Agenda Item #4

Application 2026-65-CA

Construct a single-family dwelling

Michael DeCarlo, on behalf of DeCarlo Hawker
Architects

SITE PLAN
& TITLE SHEET

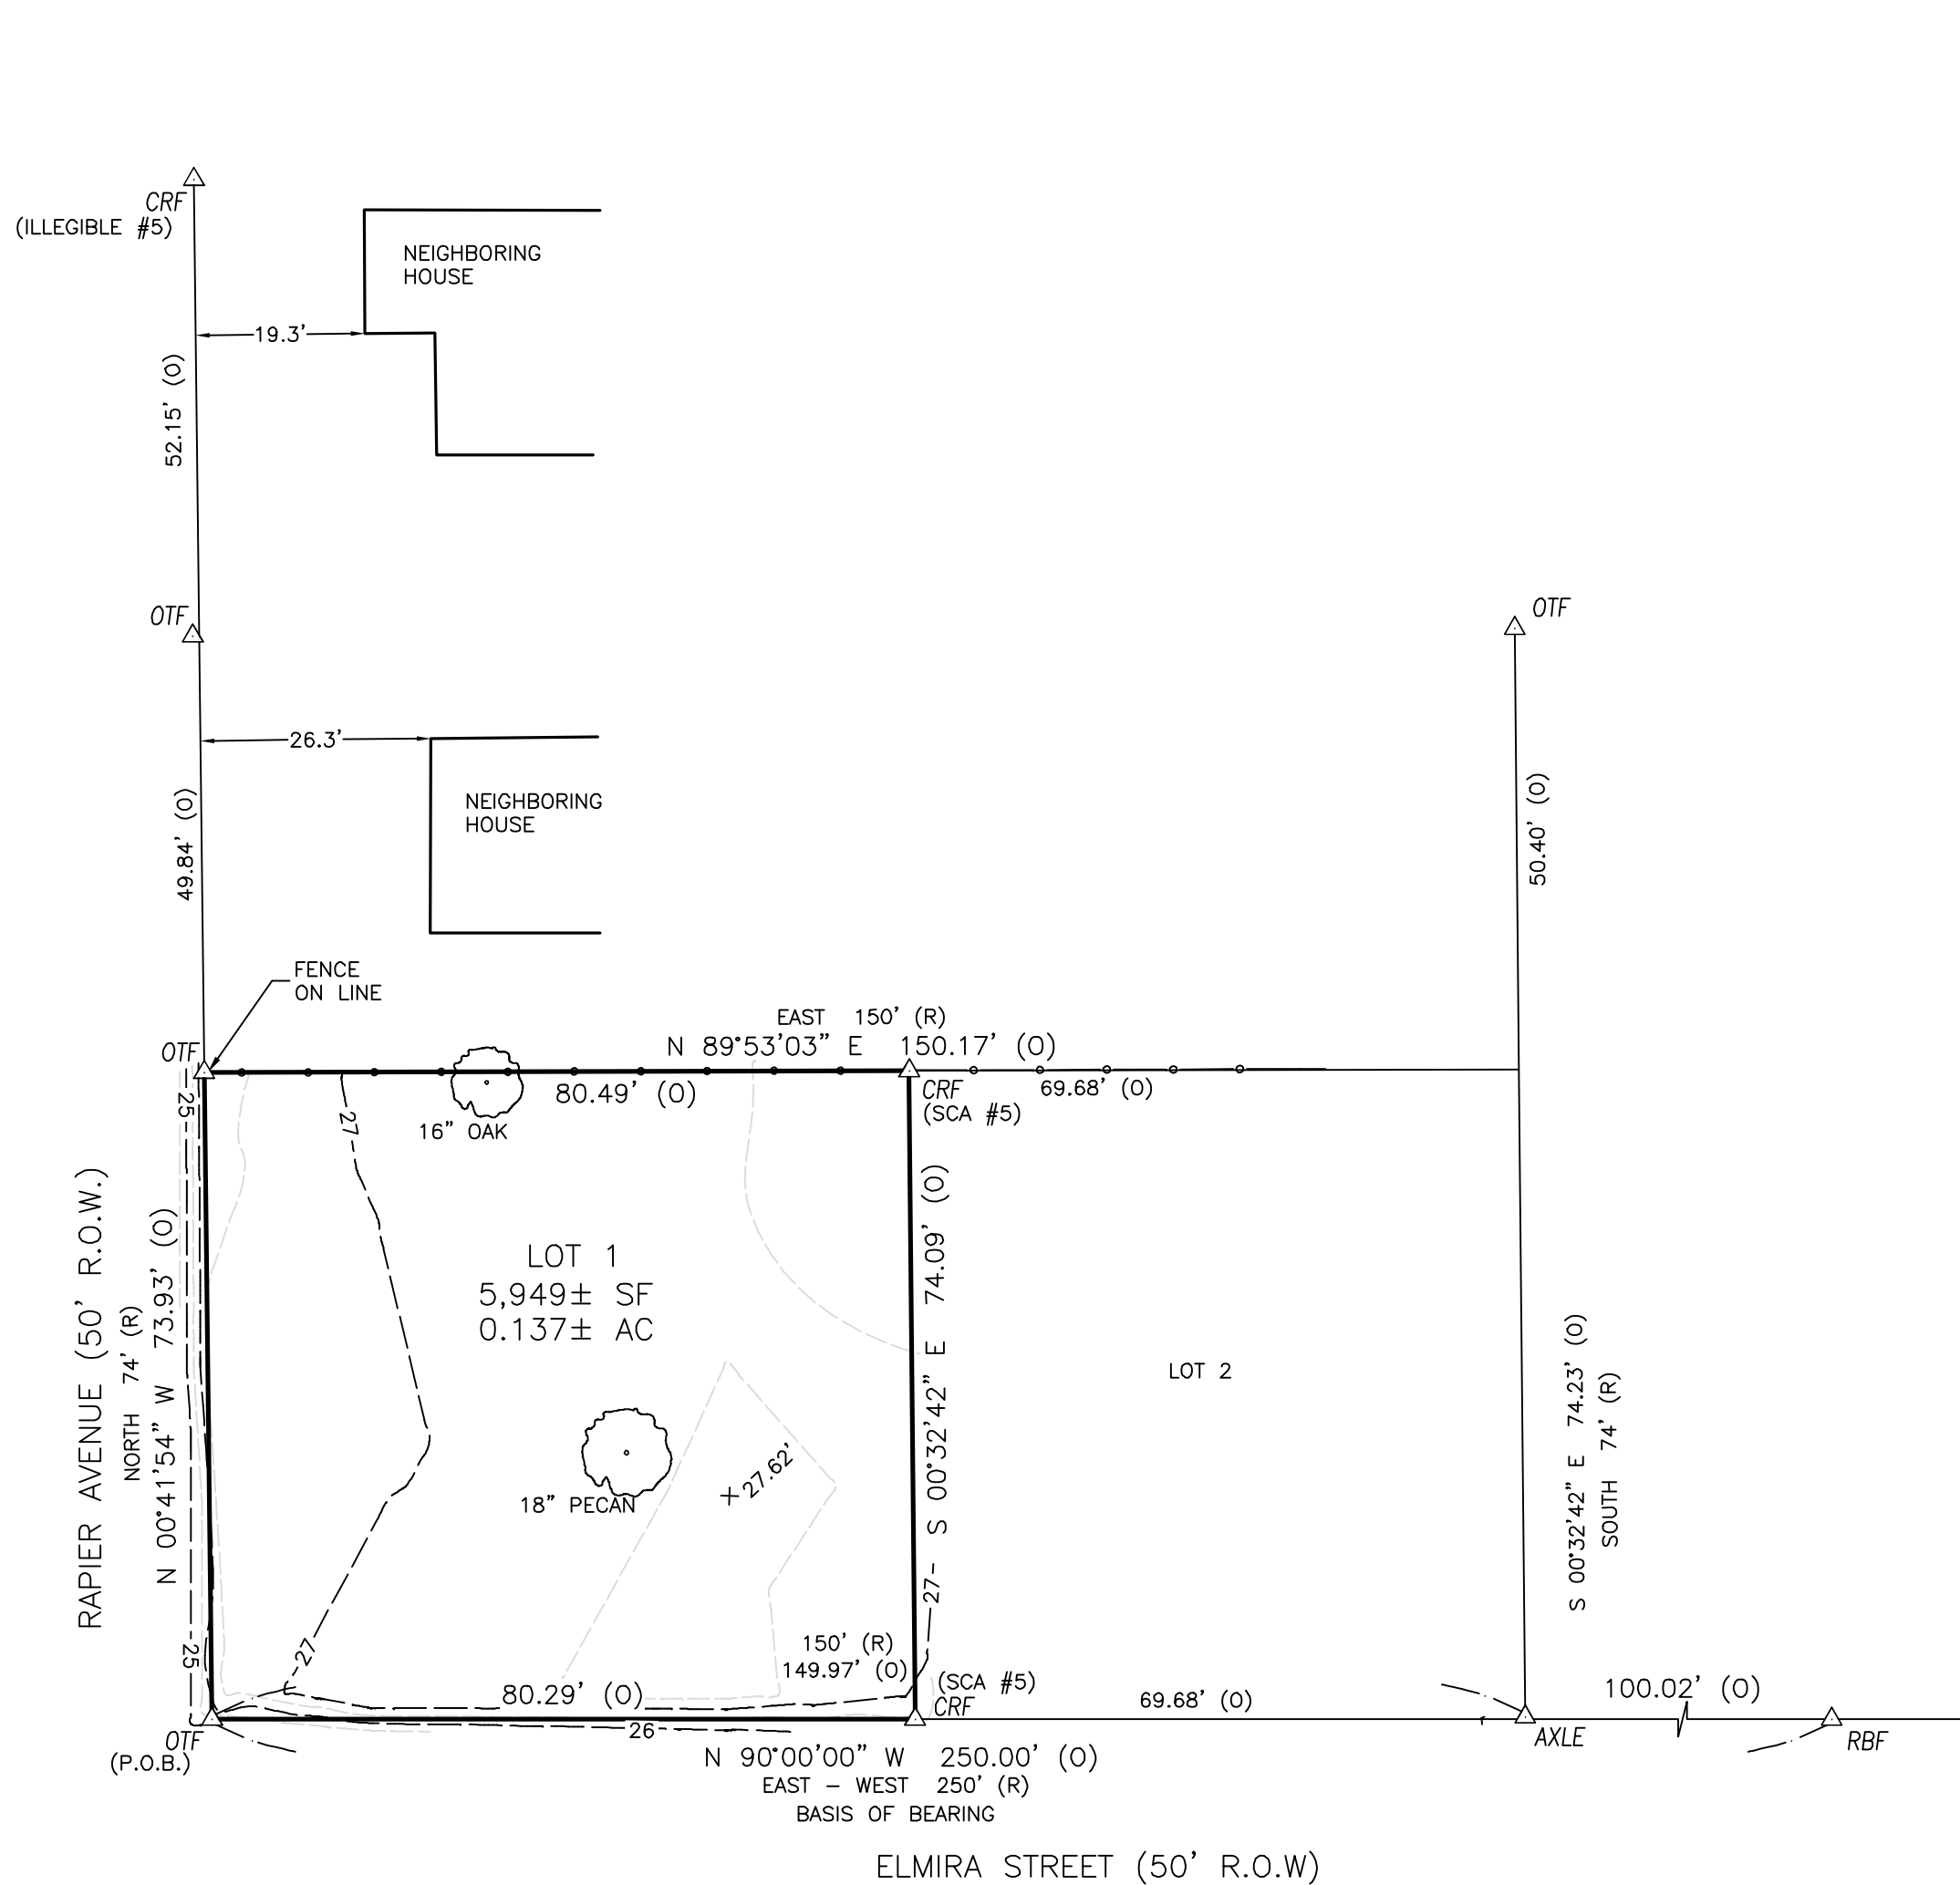
public right-of-way. The *Guidelines* advise against using paving in the front yard for a parking area (10.7). The *Guidelines* also direct that a walkway should connect the main building entry to the public sidewalk (10.5). The proposed parking area shown on the site plan is not compliant with these directives related to parking. While the existing site wall will screen the front yard parking area from view, it still impedes the pedestrian connection between the dwelling and the public realm. In particular, the front yard paving makes it impossible for a pedestrian walkway to lead directly from the main entry to the public sidewalk.

EXTERIOR
ELEVATIONS
- PROPOSED

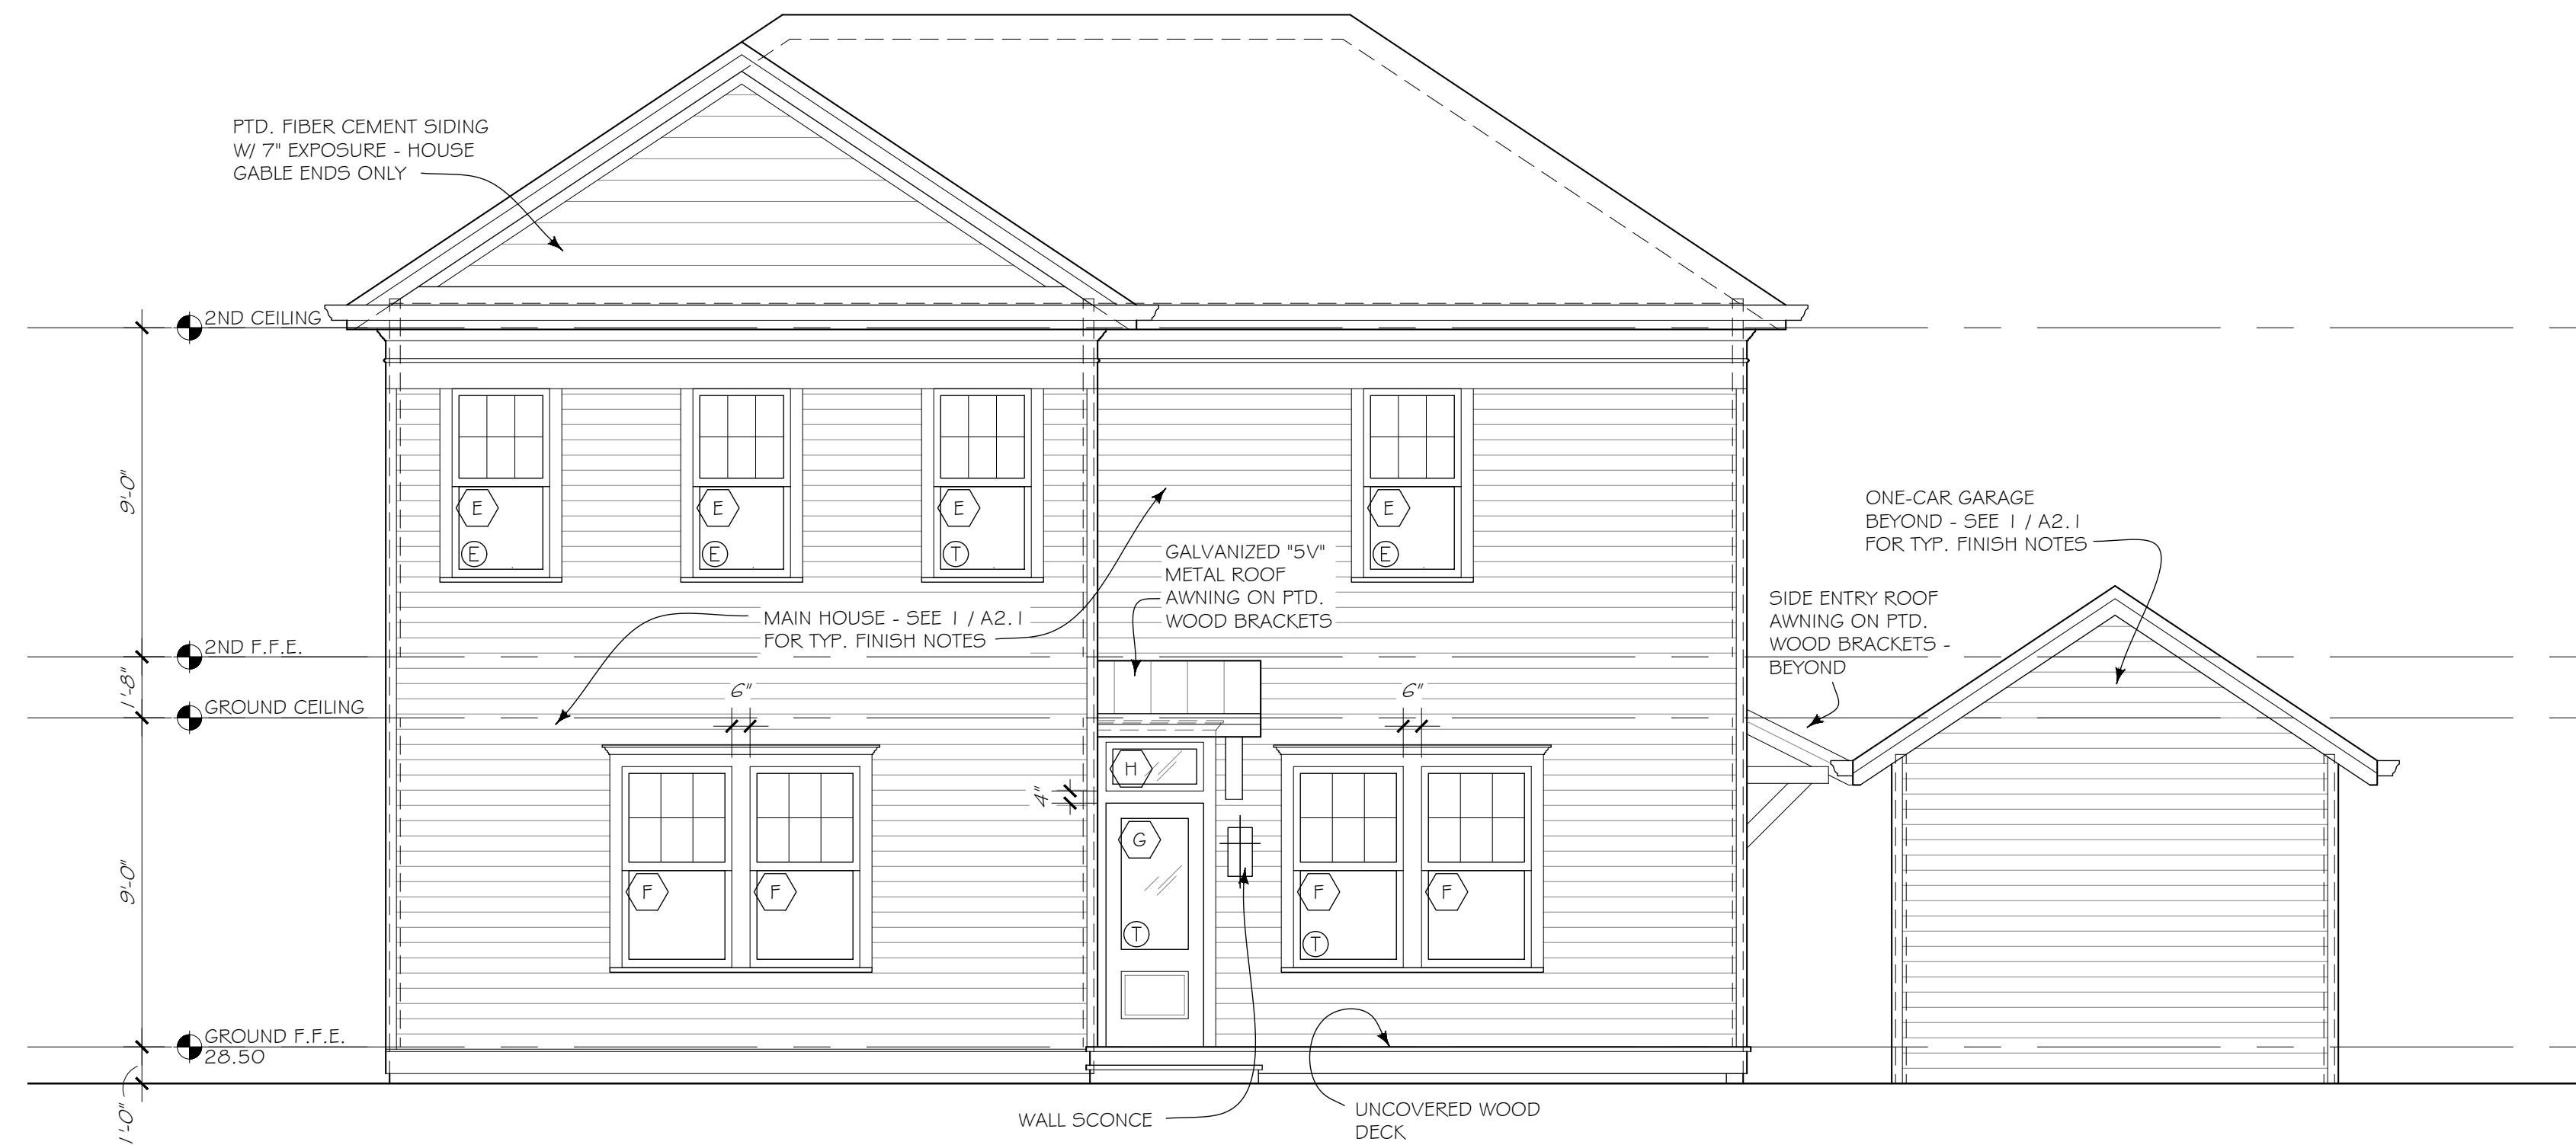
- The proposed slab-on-grade foundation is not compliant with the *Guidelines*. The slab foundation is elevated to 1'-6". Typical pier foundations in Oakleigh Garden District are between 2 and 3 feet.
- Apart from the low foundation height, the design is compliant with the *Guidelines* and compatible with the district in terms of its placement, orientation, size, massing, materials, and design.

The slab-on-grade foundation is generally not in keeping with the Oakleigh Garden District, which predominantly features homes on raised pier foundations. Some adjacent non-contributing structures – such as 1181 Elmira Street and 1159 Selma Street – are built on slabs, but raised pier foundations are typically more appropriate and better suited to Mobile’s frequent major rain events. The proposed slab would be elevated 1’-6” above grade, which is preferable to a typical slab, which may only sit 4 to 6 inches above grade. However, most adjacent

contributing structures are raised closer to 2 or 3 feet above grade on piers. A nearby exception is the residence at 304 Rapier Avenue, which is raised between 1'-6" and 2'-0" above grade. In short, a raised pier foundation would be more in keeping with the district and compliant with the *Guidelines*.

The regular fenestration patterns across the façade and side elevation are broadly in keeping with adjacent contributing structures. The two small casement windows on either side of the front entry appear somewhat unusual at first glance. However, irregular window sizes - ranging from large "cottage" windows to small, square multi-pane windows – are found on several nearby residences, including 1203 Selma Street. These smaller façade windows align with an interior staircase and powder room.
